PCN (Product Change Notice)

PCN Number: PCN_UtSTST_20251205

Affected Series: WE-STST

Affected Part Number: 74930000, 74930100

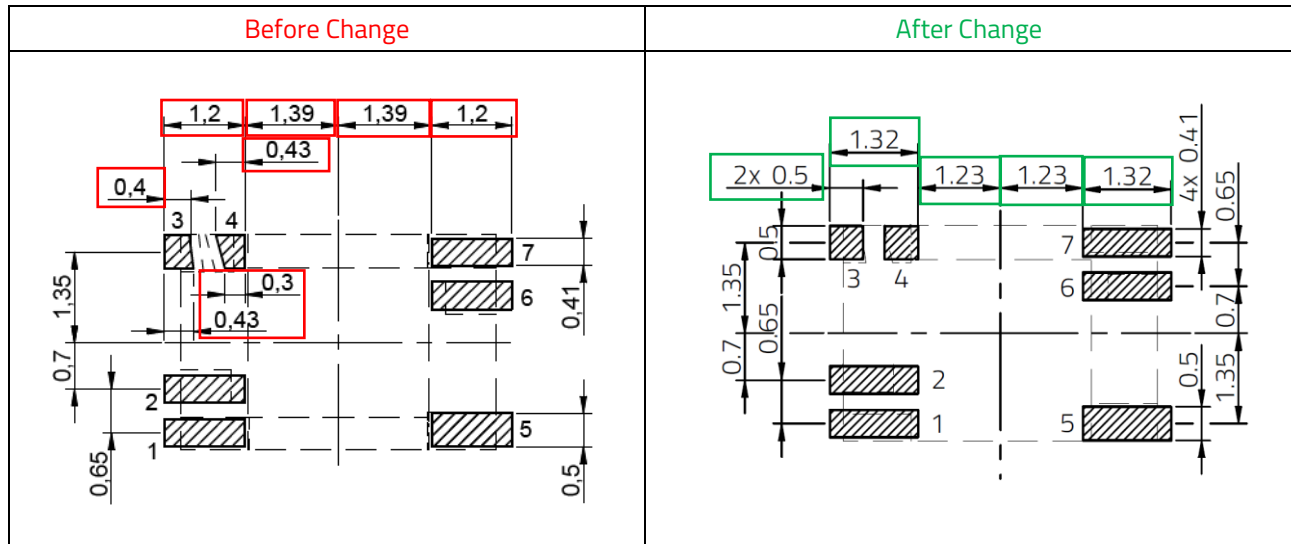
- 74930000 and 74930100: Change Recommended Land Pattern 2.

Recommended Stencil Design: [mm]

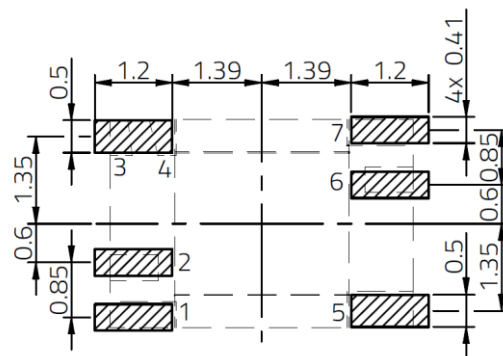
- 74930100: Add the Recommended Stencil Design.

Suggested stencil thickness: 0.08mm

Recommended Stencil Design 2: [mm]

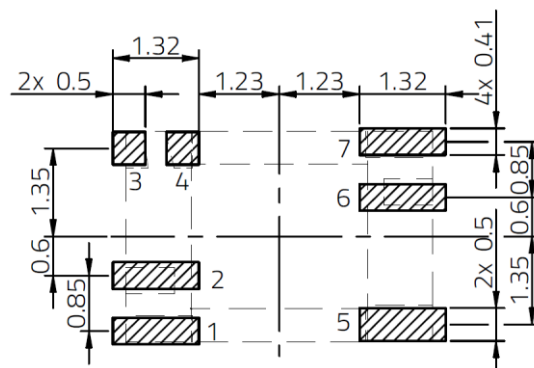
- 74930000: Add the Recommended Stencil Design 2.

Suggested stencil thickness: 0.08mm
